West Capital Airpark Phase 1B-2 Residential (Novatech Phase 2B) Servicing Report

West Capital Airpark – Phase 1B-2 Residential
1500 Thomas Argue Road
Ottawa, Ontario
Servicing Report

**Reference: West Capital Airpark – Phase 1B-2 Residential
Site Servicing Report
Our File No: 102085
City File No.: D07-16-22-0017**

This report has been revised to address comments from the City of Ottawa as indicated in the cover letter. The City review comments and response to comments are included in **Appendix A** for reference.

Plan & Profile – Phase 1B-2 Block 109 & Storm Sewer Outlet (102085-P28 rev9)

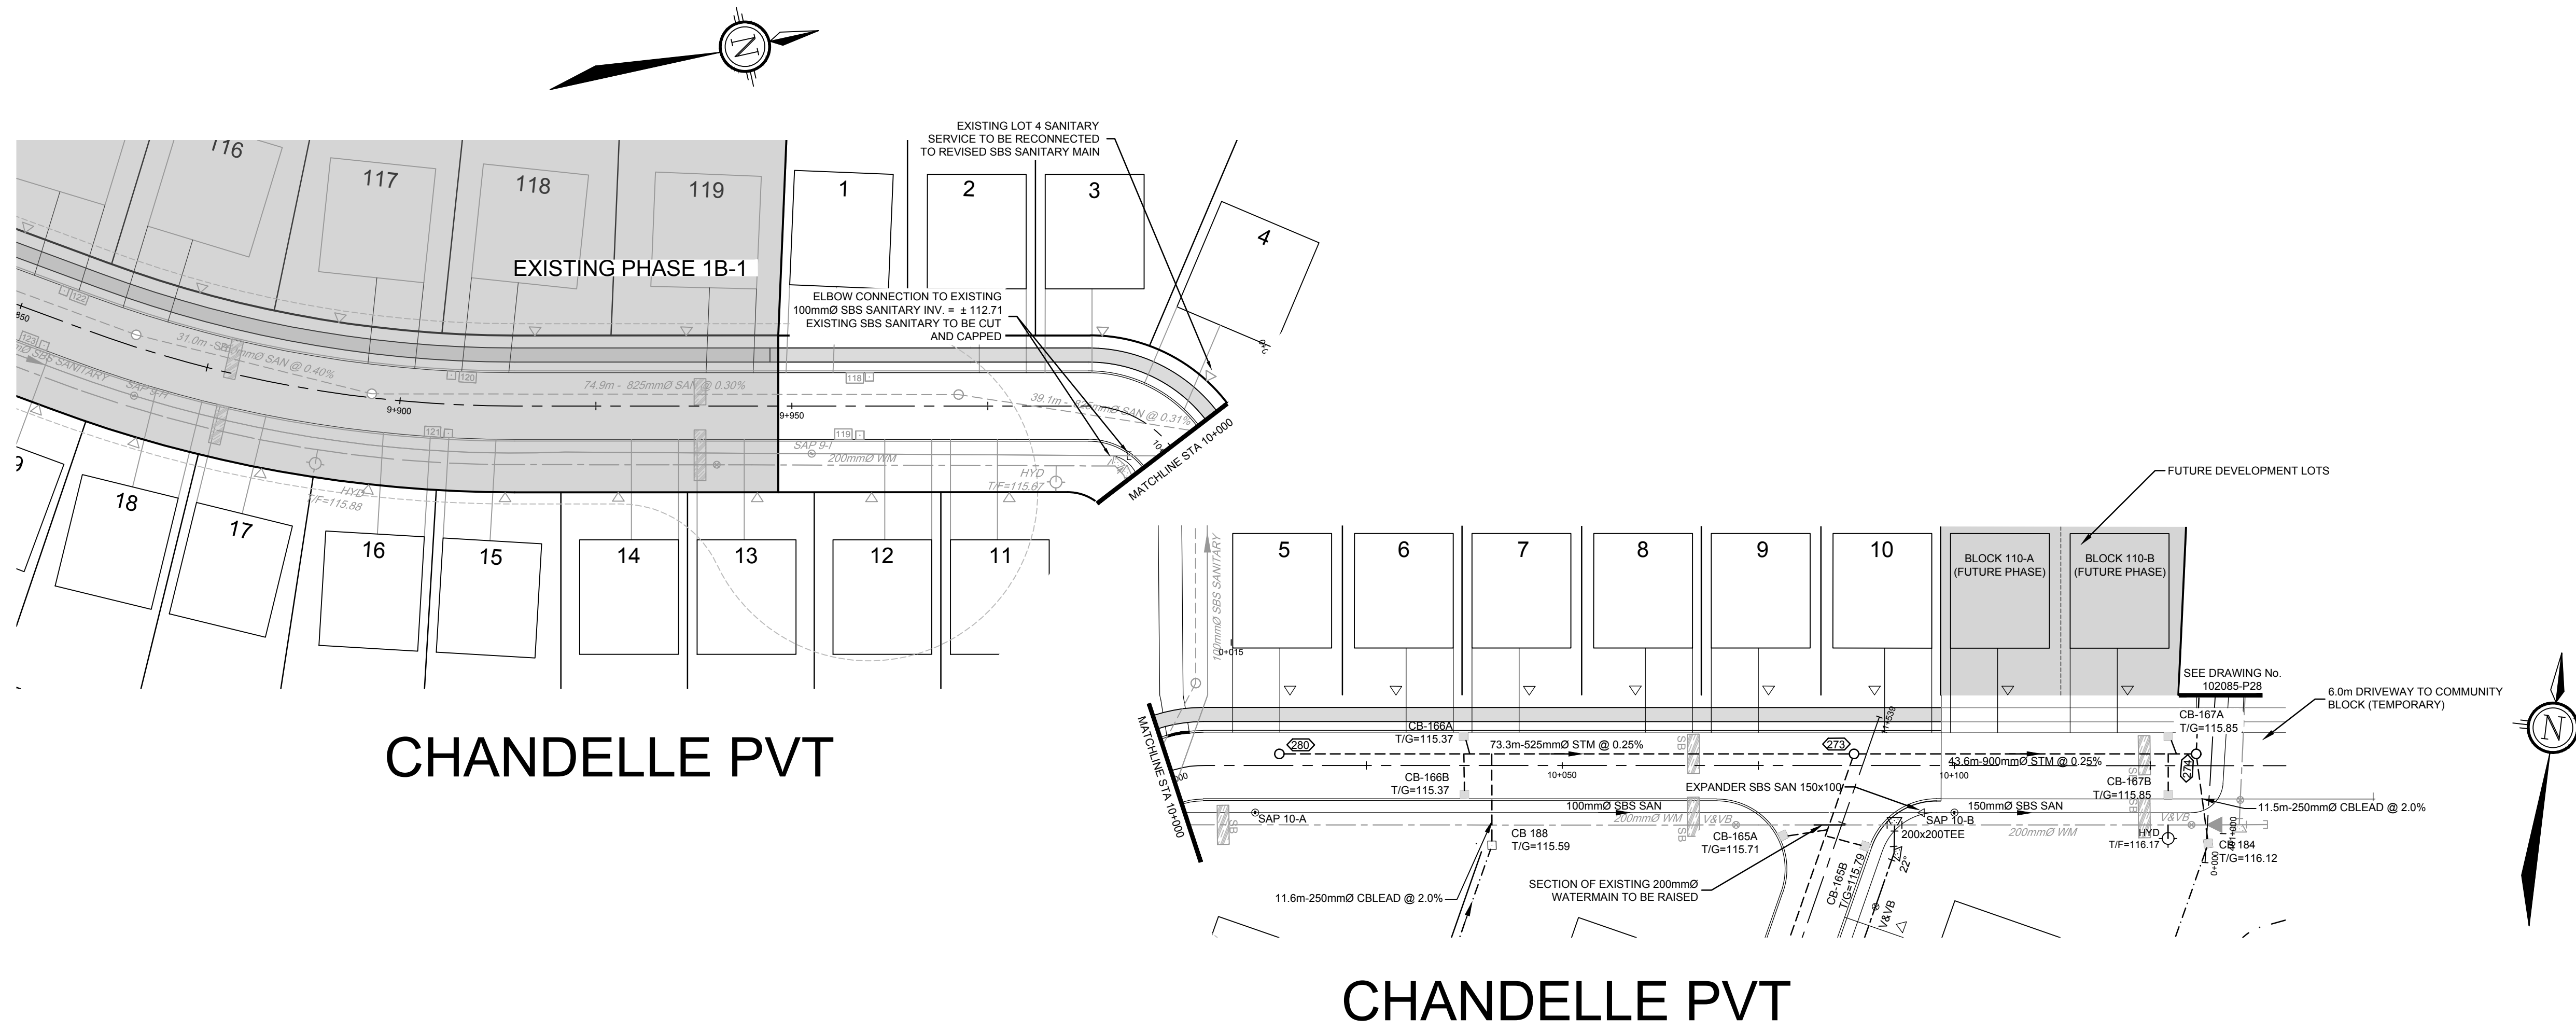
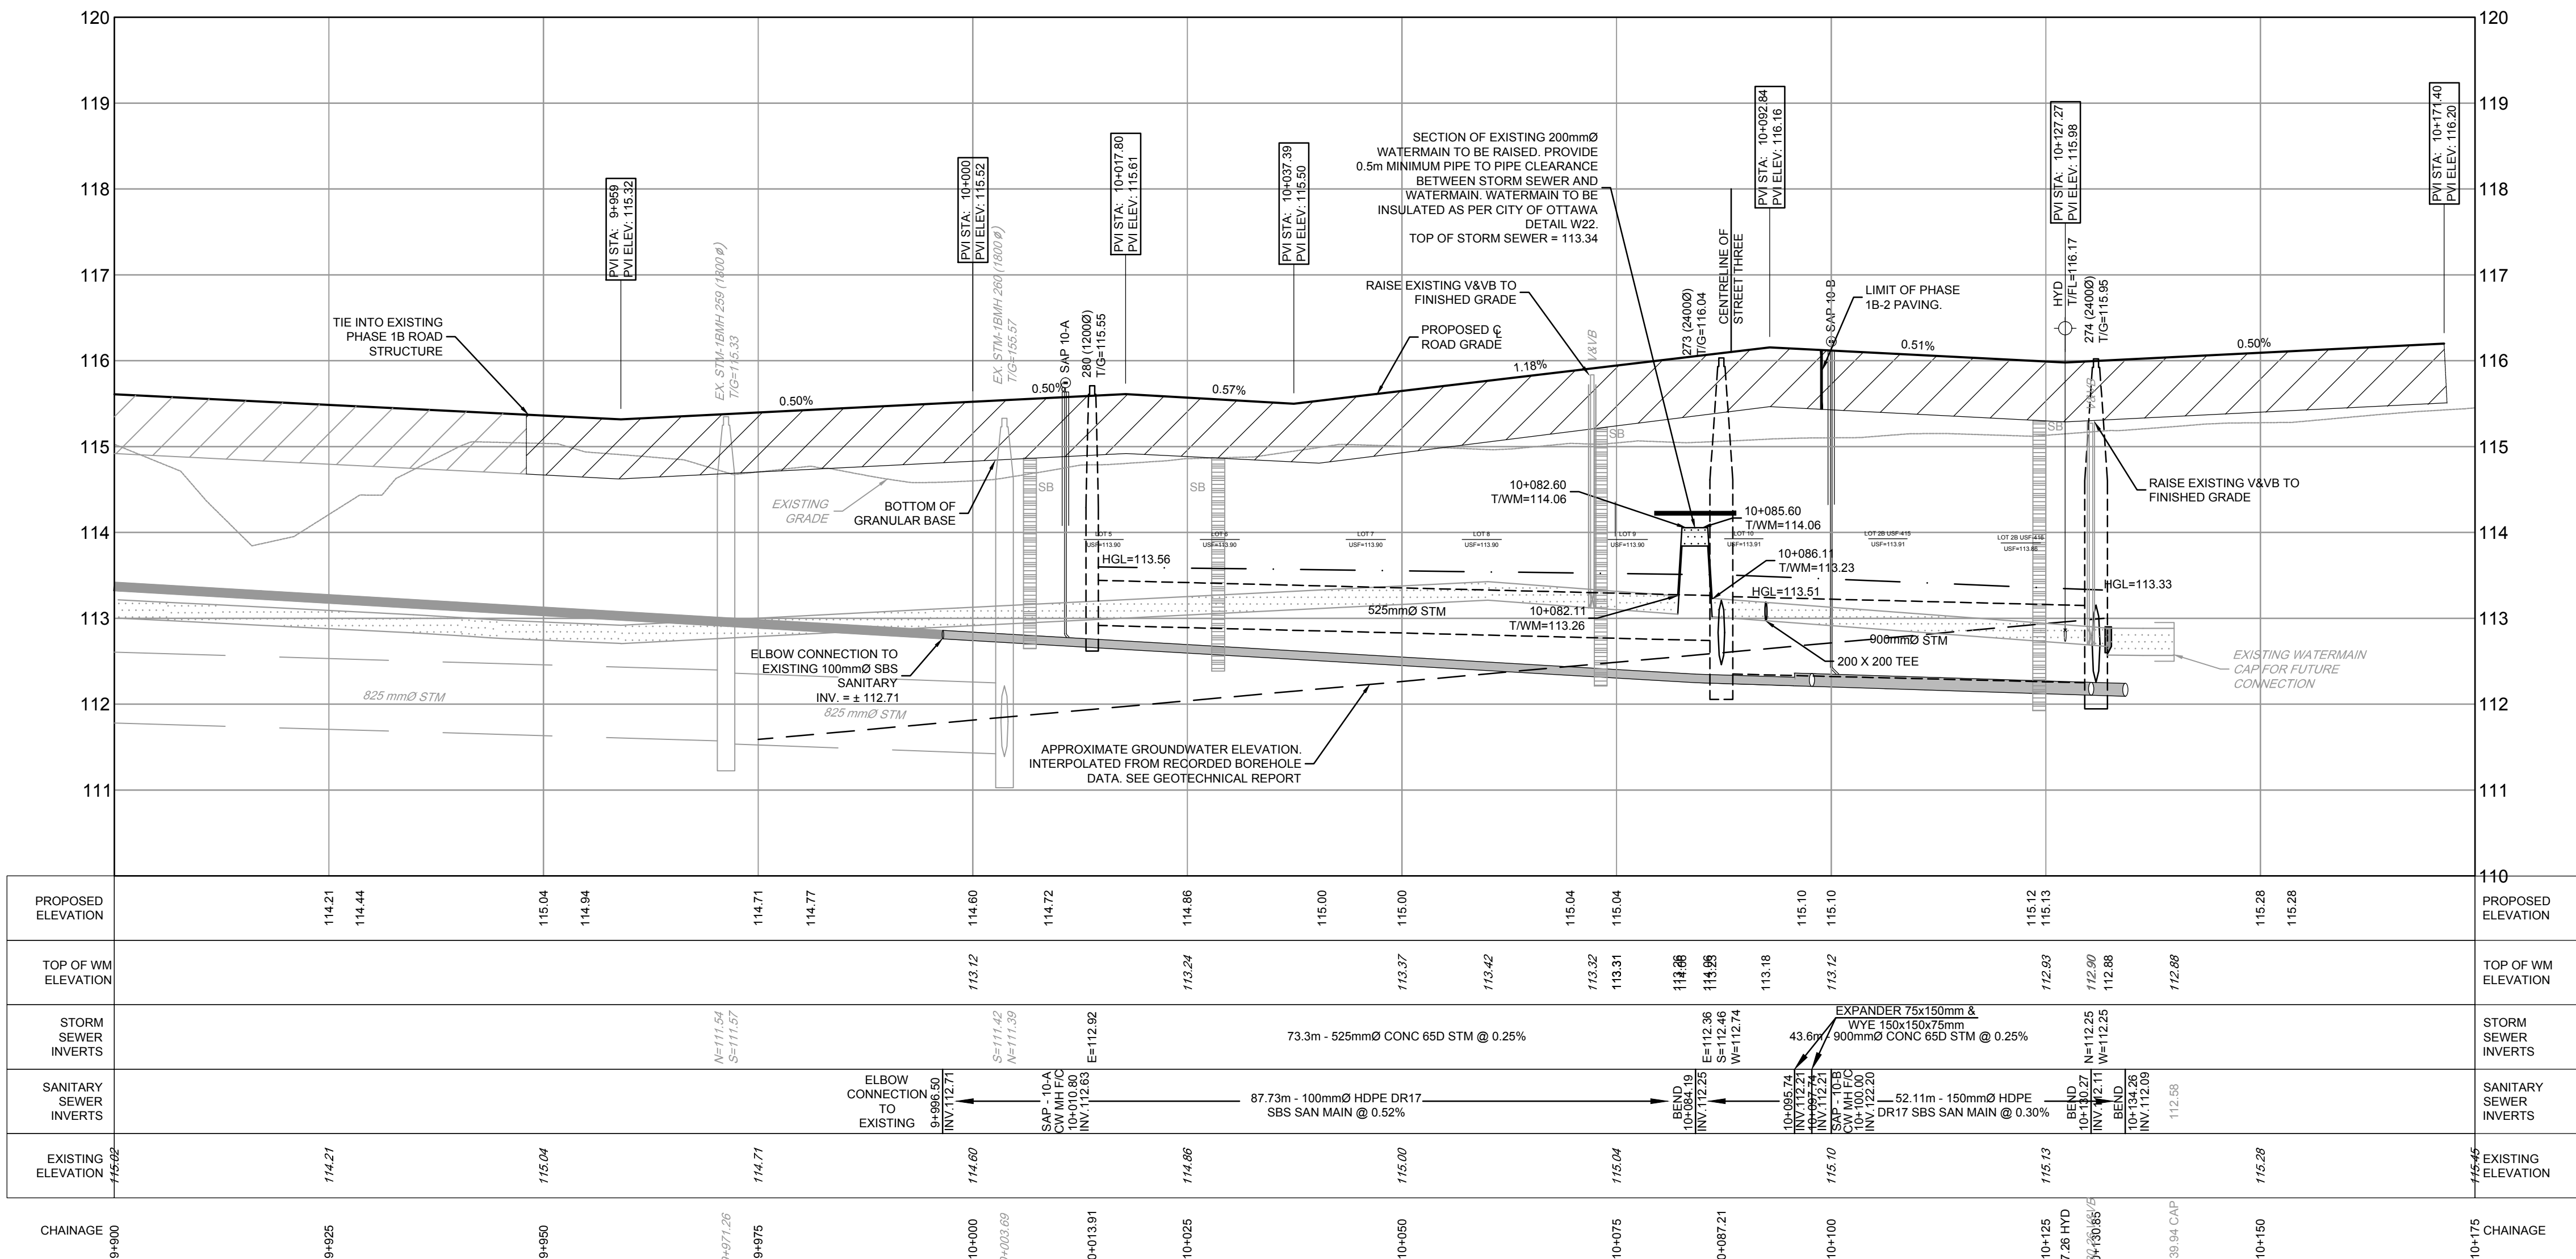
11. Profile drawing P28 show 1650 mm outlet 112.36 m then a slope down to the pond. Please extend the profile through the pond and out.
12. GR14, top left-hand corner, is the spill point drawing for Block 83?

Plan and Profile Phase 1B-2 Block 81 & Storm Sewer Outlet (102085-P28)						
1	Usually, upstream pipes are design to meet or exceed downstream pipe obverts and not as the profile indicated on the design drawing.	General			See response to General comment 2.	
2	Can you please provide us with DWG. SWMF 6 detail since the profile is incomplete.	Pond Inlet & RipRap			Additional pond inlet details are provided on drawings 102085-SWMF5 and 102085-SWMF6.

- The profile drawing for Block 81 (drawing 102085-P28) still includes offline exfiltration units. There are a few more references to exfiltration in legends and notes on various drawings. Please remove references to exfiltration units that are not part of the proposed SWM plan.

3			The profile drawing for Block 81 (drawing 102085-P28) still includes offline exfiltration units. There are a few more references to exfiltration in legends and notes on various drawings. Please remove references to exfiltration units that are not part of the proposed SWM plan.	The exfiltration trench has been removed from profile drawing 102085P28.	OK
